City of Conway

ORDINANCE NO. O-05-75

AN ORDINANCE AMENDING THE CONWAY SUBDIVISION ORDINANCE O-00-03 ADOPTED JANUARY 25, 2000 TO BRING SAID ORDINANCE INTO COMPLIANCE WITH THE ARKANSAS STATE FIRE CODE, DECLARING AN EMERGENCY AND FOR OTHER PURPOSES:

Figure A

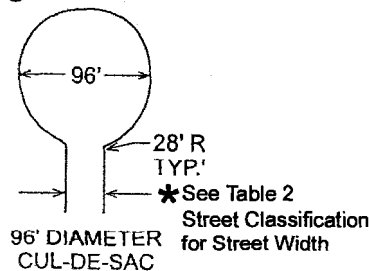
d. An acceptable turnaround shall be provided at the end of all permanent dead-end streets exceeding 150 feet in length. Turnarounds for residential and commercial streets shall conform to dimensions and requirements shown in Figure A, Table 1, and Table 2. A 96 foot diameter cul-de-sac requires a 120-foot right-of-way. Measurements assume back of curb to back of curb for a roll curb.
